Compatibility WMK 2005 / WMK 2010 / WMK 2030 to predecessor

This document contains additional information about the backward compatibility of the new generation encoders compared to the predecessors WMKF-205x / WMKF-20x/WMKF-30x. For discontinuation announcement see customer information #1/2016:

Customer information #4/2016

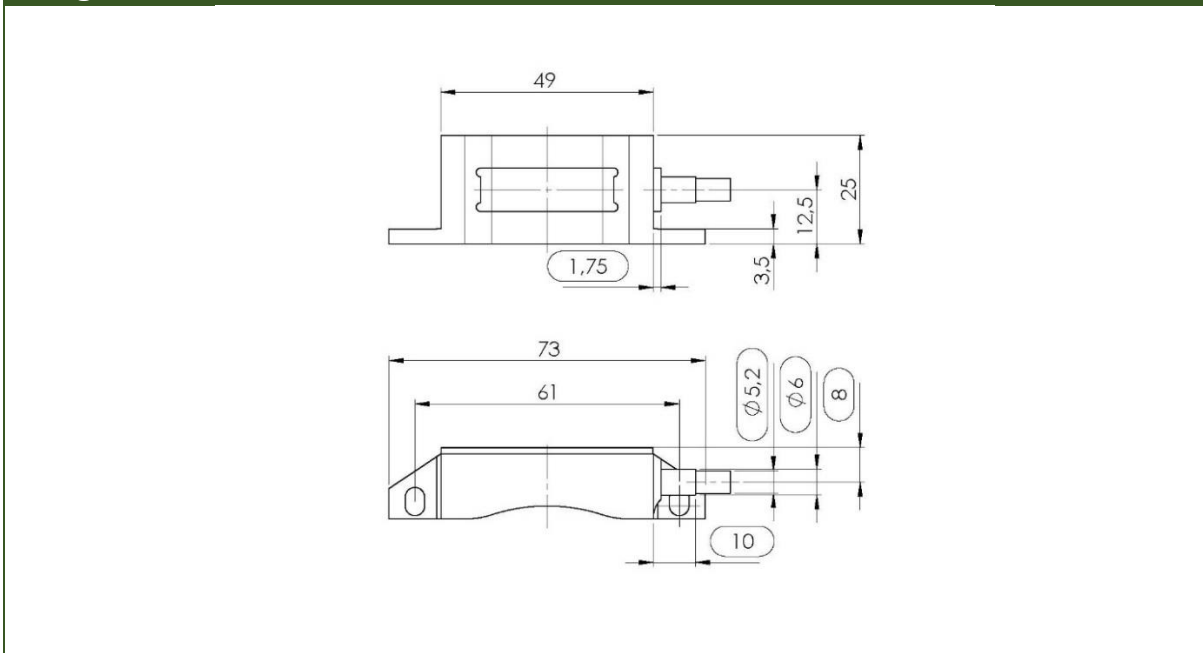
Angle encoders with TTL Interface and an interpolation factor of 1000 (which means a resolution of 0,25 μ m arc length based on a grating period of 1000 μ m) won't show up any more as a price list device.

But there is a backward compatible version available to continue existing applications.

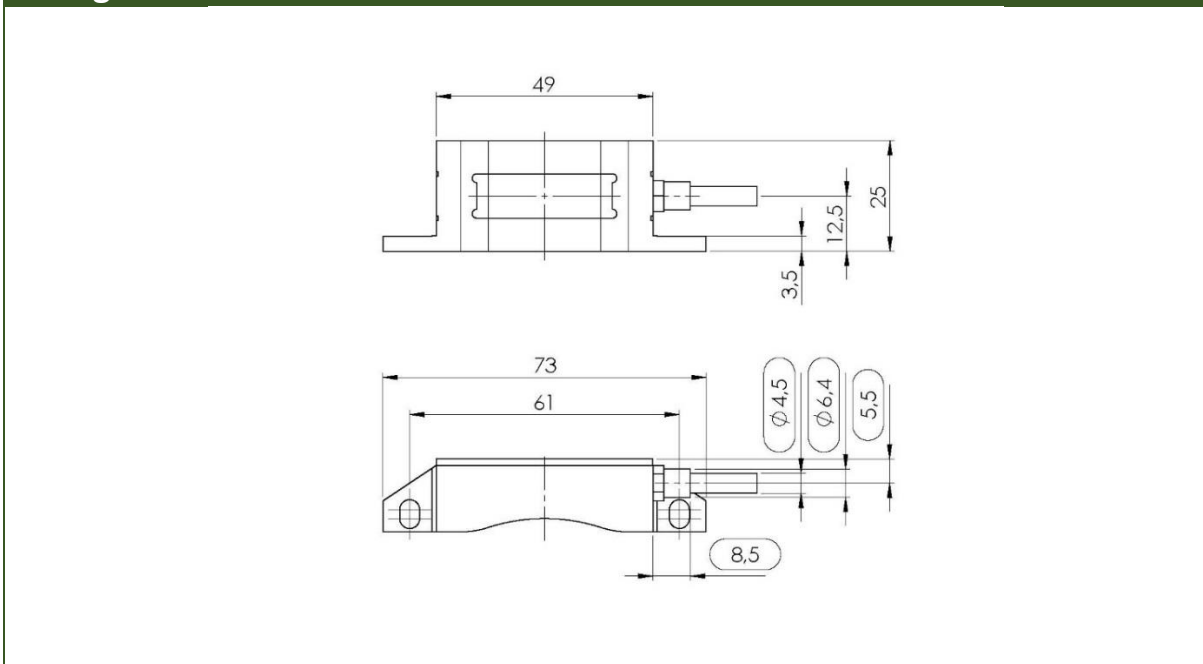
The mechanical dimensions are identical except an improved cable gland (optimizing EMI behaviour) compared to the previous version.

Mechanical dimensions shown in the following drawings. Differences in mechanical dimensions are indicated.

old generation

new generation
